GULMOHAR RESIDENCY

Details of Additions & Alterations

Flat No	406.	Block no.	C.
Flat Area	1660 sft	Type	Deluxe / Luxury
Buyer Name	Satish . S.		
Phone No.		Email

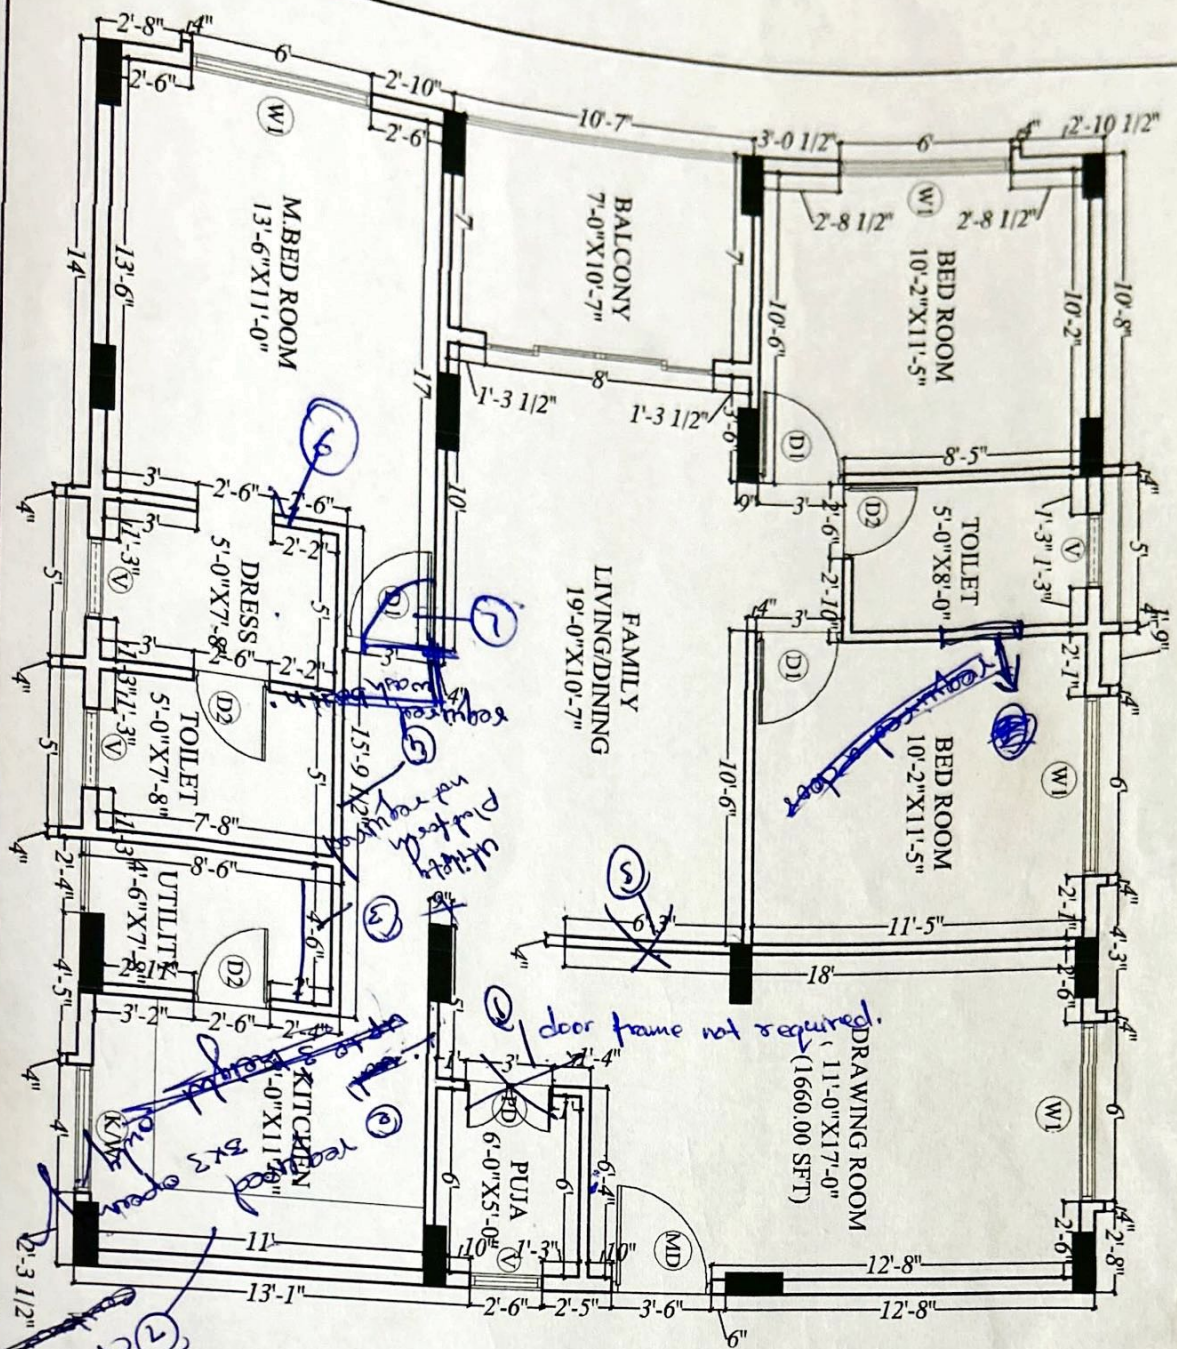
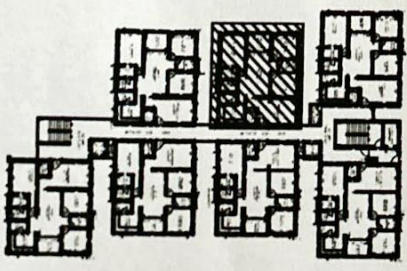
- ① Pooja door frame not required.
- ② Required $3' \times 3'$ opening attached to Pooja room as mentioned in drawing.
- ③ Utility step not required for washing machine.
- ④ Required wash basin.
- ⑤ Partition wall of $6'3''$ not required.
- ⑥ Dressing room not required.
- ⑦ Door position has to be changed changed as per drawing.
- ⑧
